Access Compliance Report

Public Rights-of-Way

(Curb Ramps)

| Intersection ID: 26629 | Main Street: ALPINE_FOREST_CT | Cross Street: MANOR_HOUSE_DR | Location: SW |

| ADA ID: 5EBB2C34D531 | Ramp Type: BlendTrans1 | Initial Pass/Fail: Fail | Overall Compliance: No |

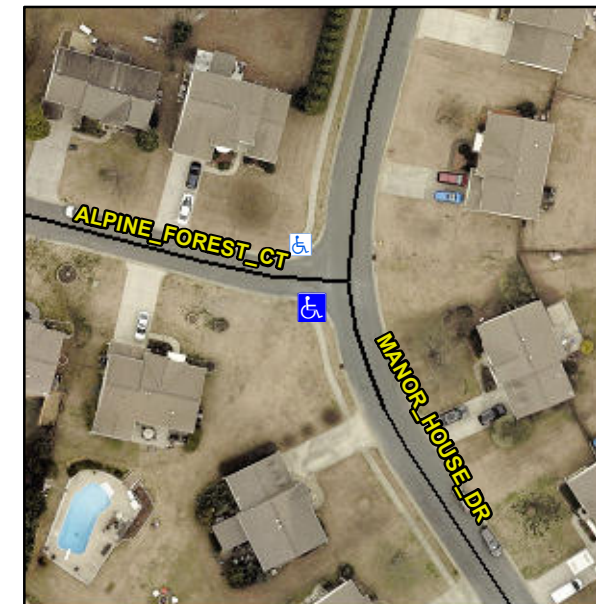
Not Found, R304.5.3

| Compliance | Description | Data | Compliance | Description | Data |
|------------|-----------------------|------|------------|-----------------------------|------|
| Yes | Ramp Width (in) | 48.0 | No | BlendTrans XSlope (%) | 3.0 |
| | | | No | Curb Slope (%) | 14.6 |

Remove & Replace Curb Ramp With Two New Directional Ramps or Equivalent.
